**Re. Current Balboa Park Plans**

The San Diego Council of Design Professionals and the San Diego Chapter of the American Institute of Architects have formed a task force to review the preliminary plans by Civitas with the purpose of developing a position for consideration by your committee, the Park and Recreation Board, national and local historic review boards, the Planning Commission, and the San Diego City Council. We are very pleased that the City is addressing the long standing problem of traffic and parking in Balboa Park and we strongly support the concept of a parking garage behind the Organ Pavilion. In this case the at-grade rooftop would join adjacent reclaimed parkland, an exciting premise!

Please see attachment of our proposed design.

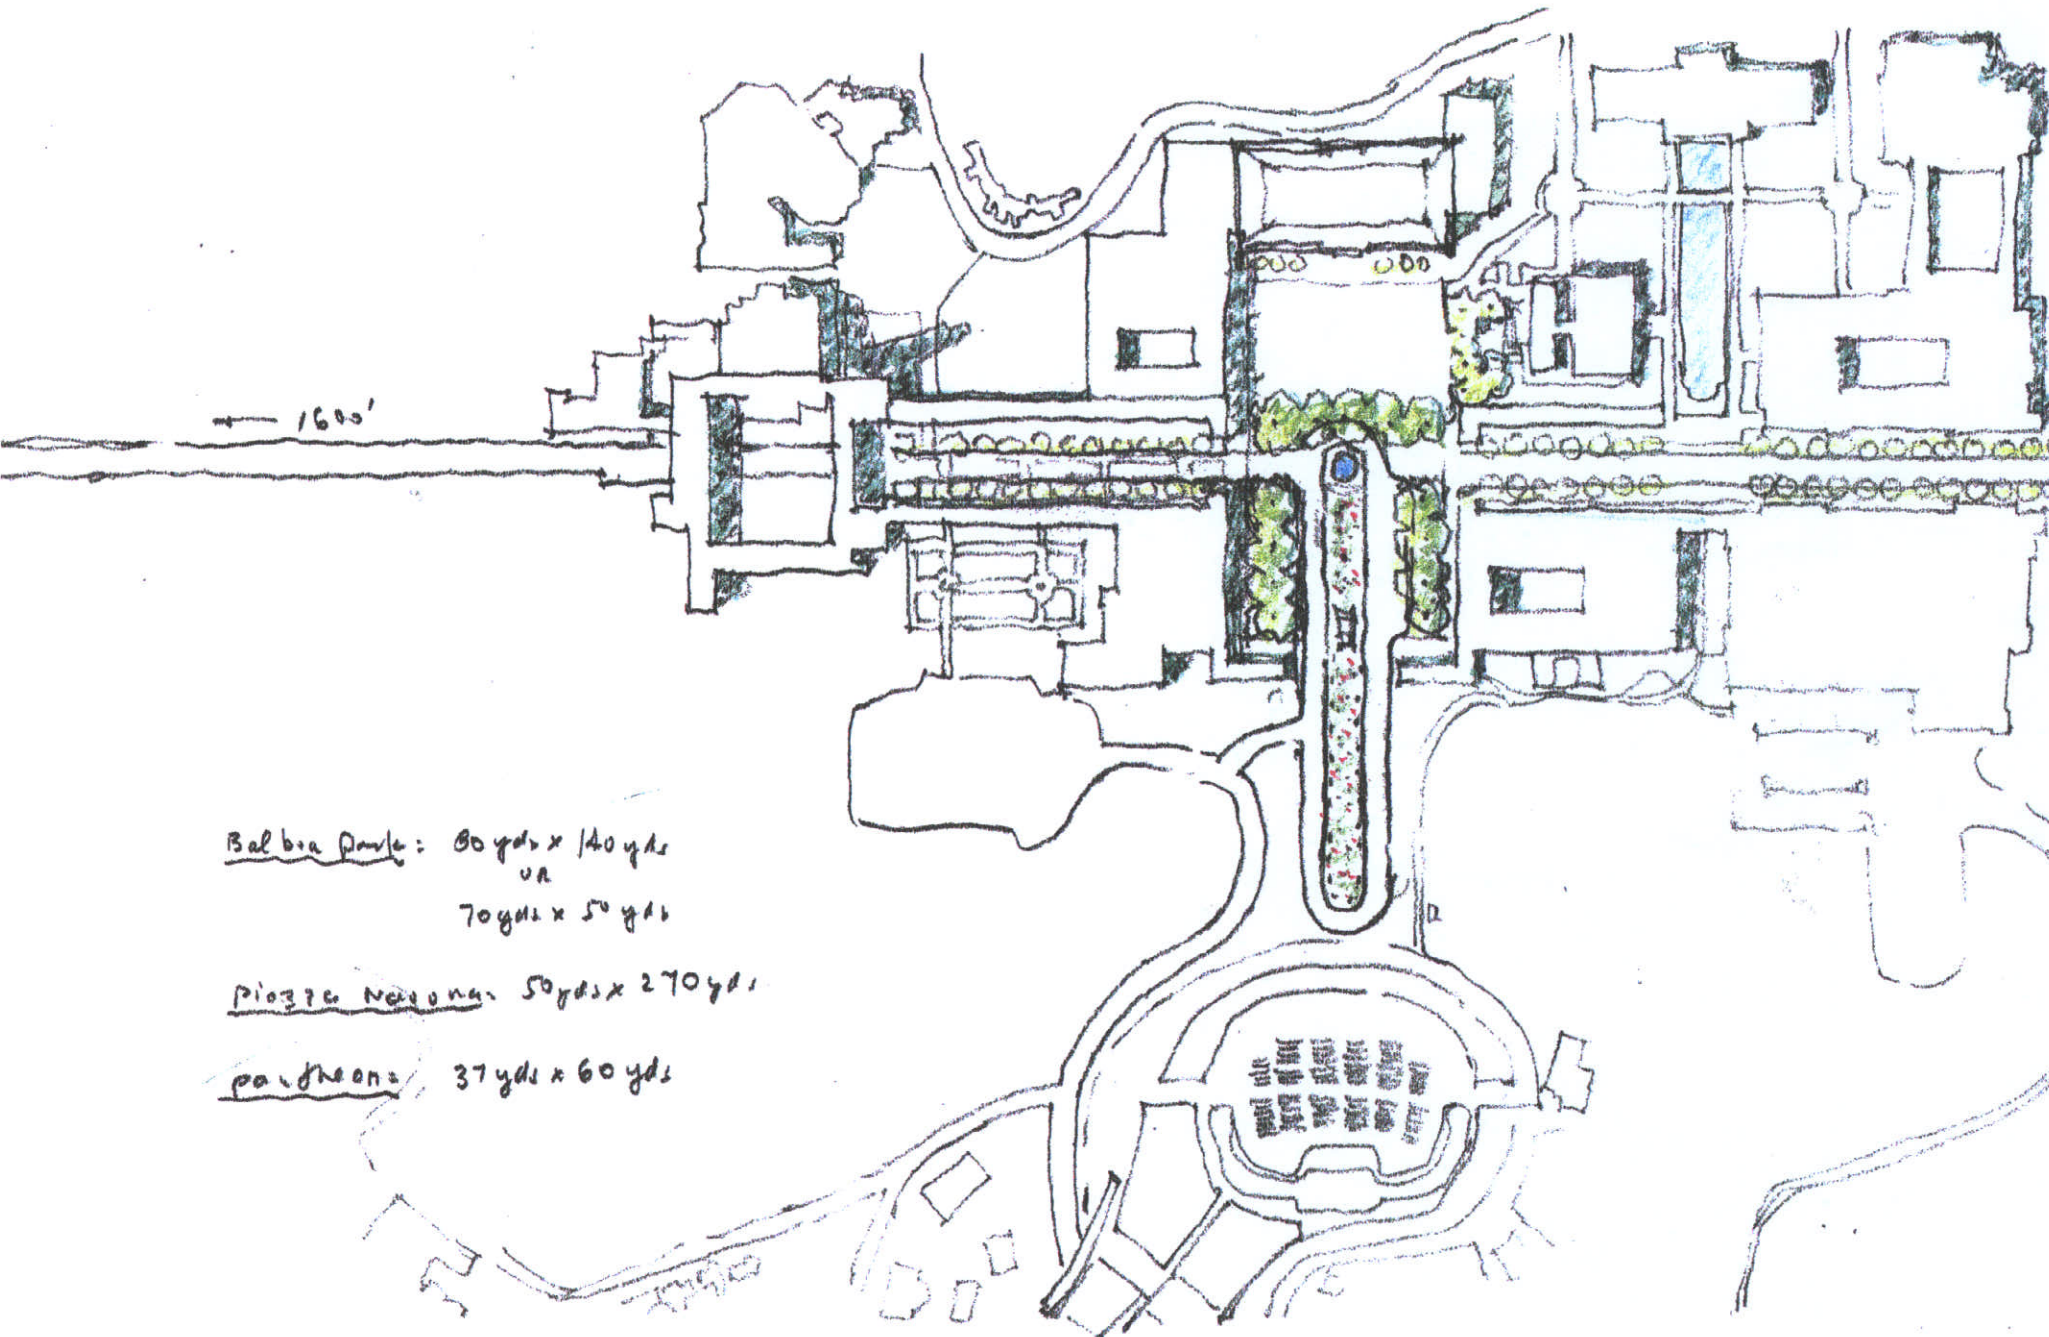
1. Develop an Art Museum-Timken "piazza" the size of similar large European plazas and create an El Cid island, or "Isla del Cid," We feel the Plaza de Panama in its entirety at some 70 yards by 140 yards, would be uncomfortably large and would render the museums remote when cut off from all passing traffic and from convenient drop-off zones.

2. Include a car-free PanAmerican Plaza, which, interestingly, is exactly the size of the dramatic Piazza Navona in Rome.
3. Whereas passenger drop-off areas should be provided near the theaters and museums, we believe that both main plazas should be permanently closed to parking. We also recommend that the Alcazar Gardens parking lot remain as a drop-off area and parking for handicapped.
